**ZONE 7 WATER AGENCY  
MOCHO 2 WELL REPAIR PROJECT  
# 264-17  
ADDENDUM NO. 1  
January 26, 2018**

This Addendum No. 1 (“Addendum”) is dated the date set forth above and modifies certain Bidding Documents issued by the Alameda County Flood Control and Water Conservation District, acting by and through its Zone 7 Water Agency (“District”) in connection with the District’s project: *MOCHO 2 WELL REPAIR PROJECT- Project # 264-17.*

**MOCHO 2 WELL REPAIR PROJECT**  
CIVIL  
**STILLING BOX & NEW 12" DIP PIPING & MAGNETIC FLOWMETER**

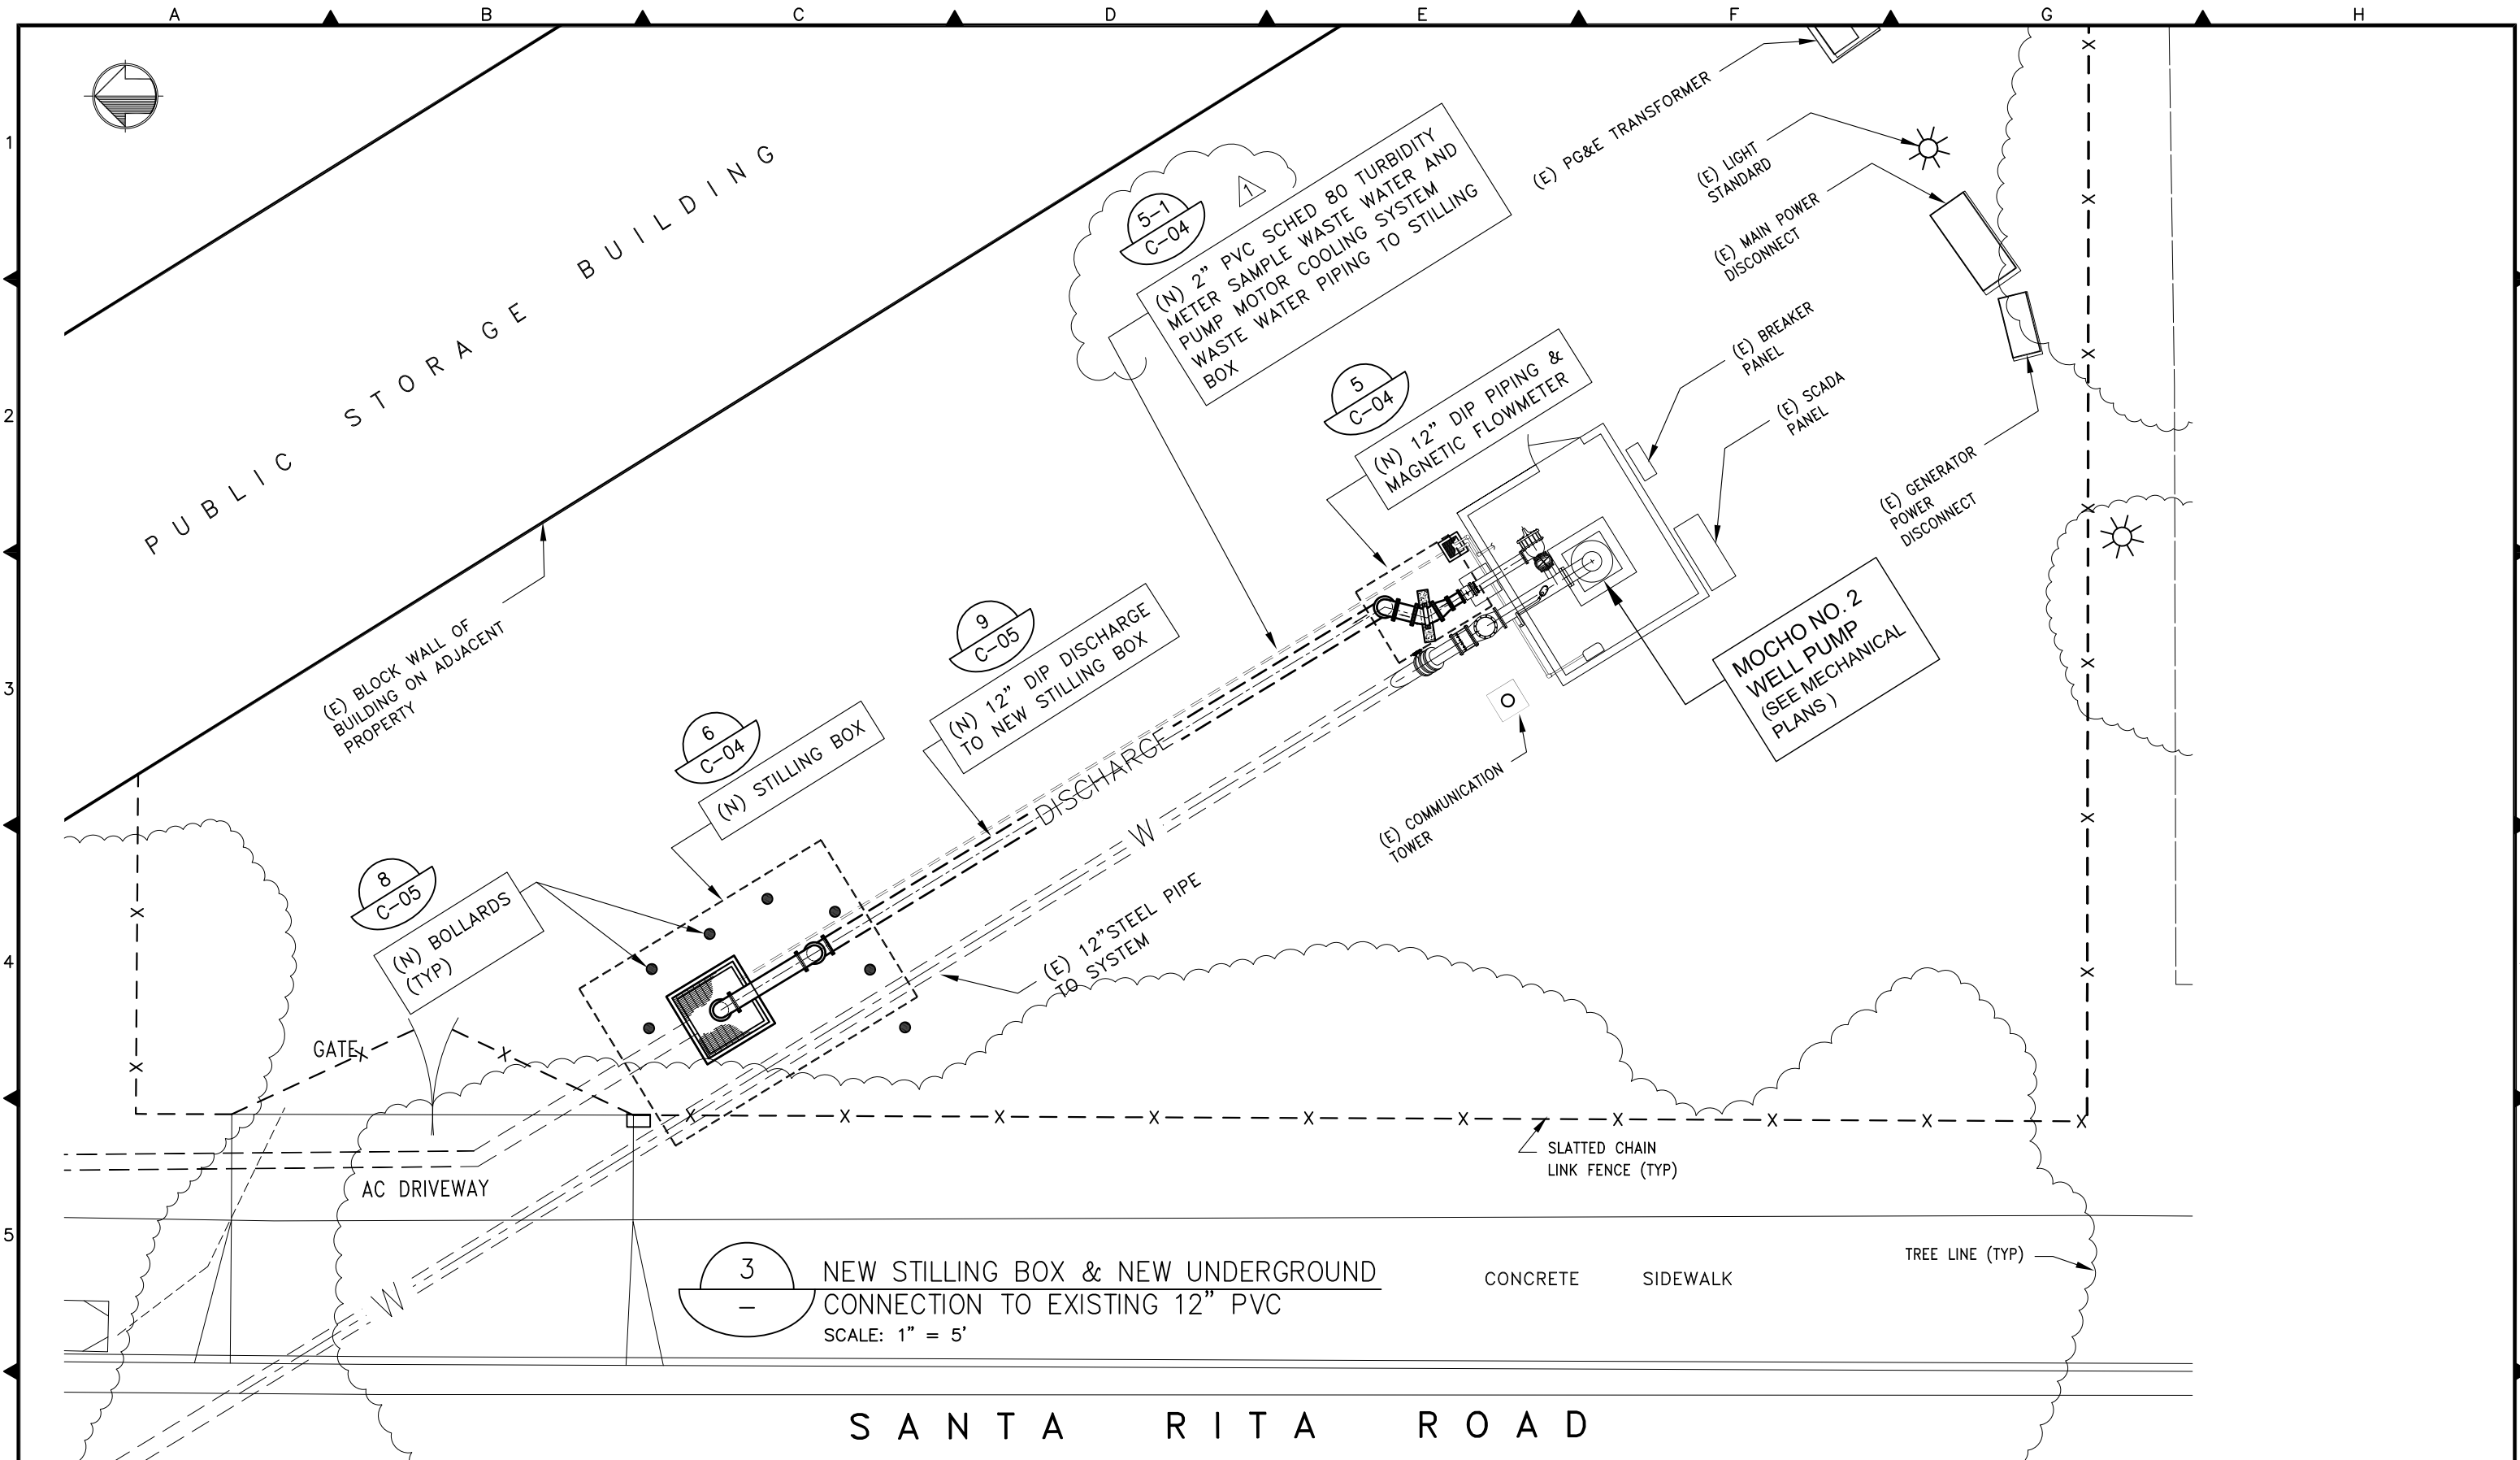
REV	DATE	BY	Description
Δ	01/25/2018	ESB	SPECIFY STEEL PIPE CLAMP AND ADD TURBIDITY METER SAMPLE WASTE AND PUMP MOTOR COOLING WASTE PIPING TO DRAIN DETAIL.

**MOCHO 2 WELL REPAIR PROJECT**  
 CIVIL  
**CONSTRUCTION DETAILS**

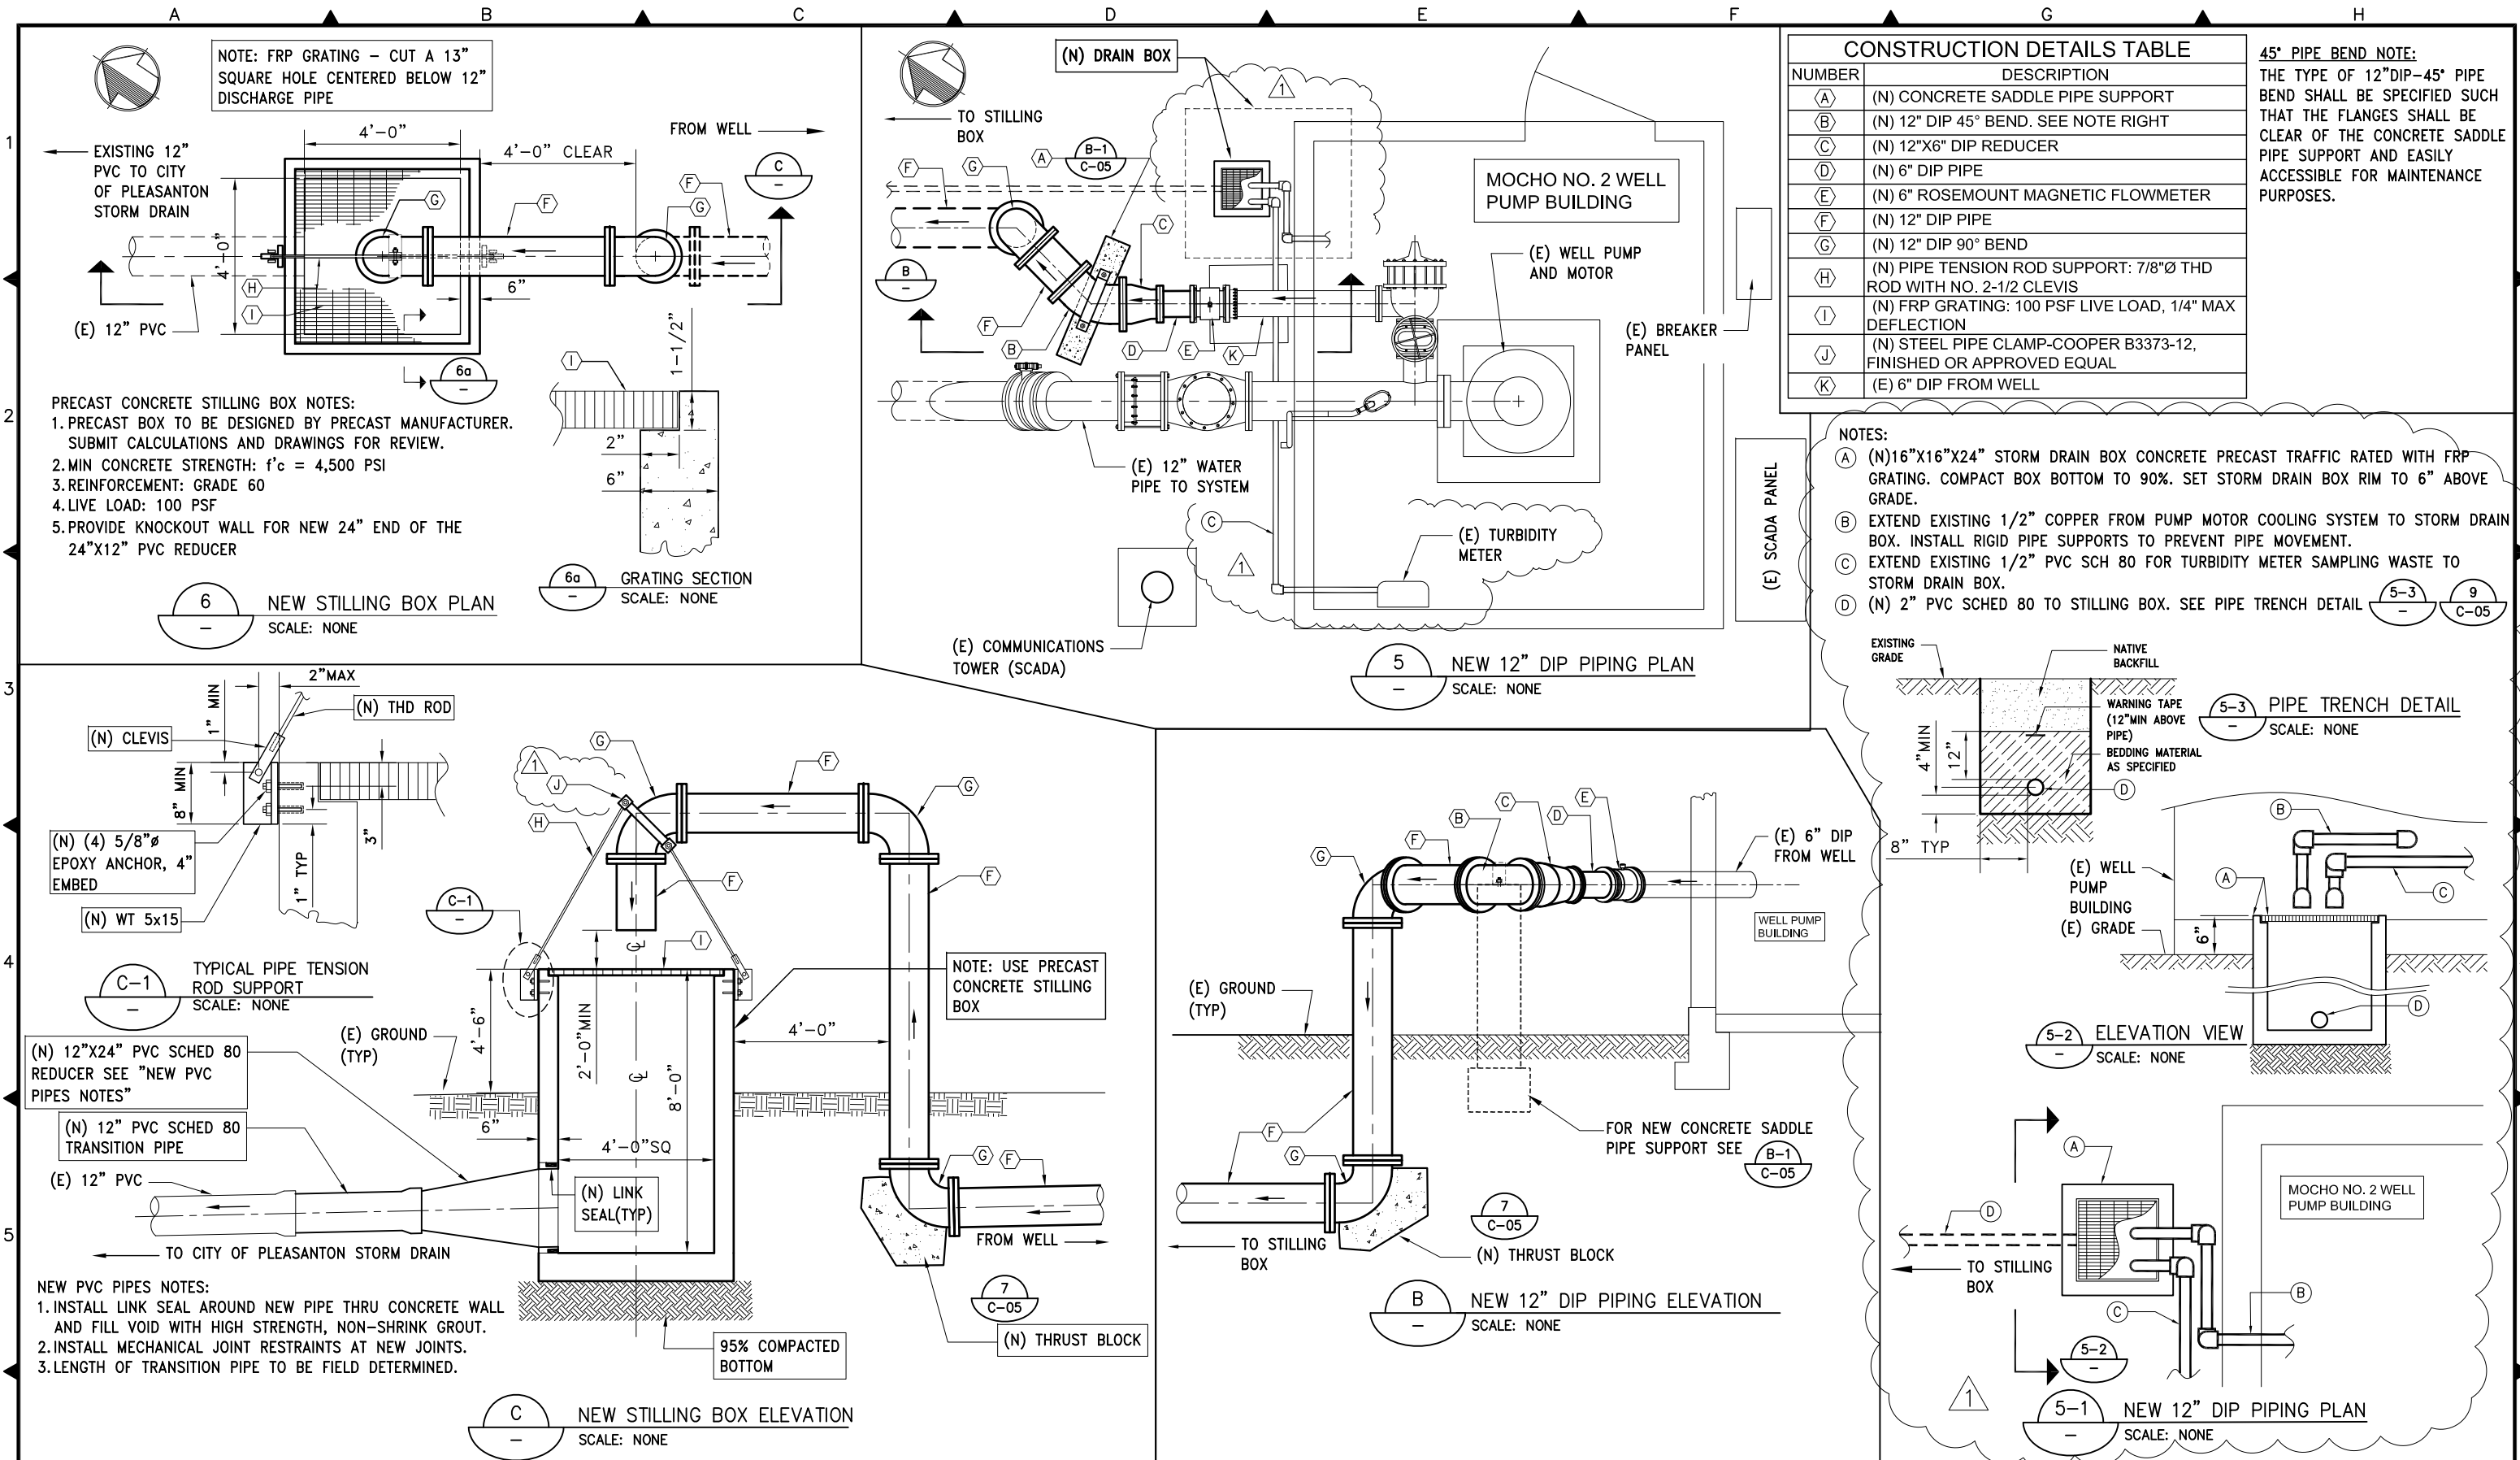
REV	DATE	BY	Description
Δ	01/25/2018	ESB	SPECIFY STEEL PIPE CLAMP AND ADD TURBIDITY METER SAMPLE WASTE AND PUMP MOTOR COOLING WASTE PIPING TO DRAIN DETAIL.

- NOTES:  
 (A) (N) 16"x16"x24" STORM DRAIN BOX CONCRETE PRECAST TRAFFIC RATED WITH FRP GRATING. COMPACT BOX BOTTOM TO 90%. SET STORM DRAIN BOX RIM TO 6" ABOVE GRADE.  
 (B) EXTEND EXISTING 1/2" COPPER FROM PUMP MOTOR COOLING SYSTEM TO STORM DRAIN BOX. INSTALL RIGID PIPE SUPPORTS TO PREVENT PIPE MOVEMENT.  
 (C) EXTEND EXISTING 1/2" PVC SCH 80 FOR TURBIDITY METER SAMPLING WASTE TO STORM DRAIN BOX.  
 (D) (N) 2" PVC SCHED 80 TO STILLING BOX. SEE PIPE TRENCH DETAIL (5-3) (9 C-05)
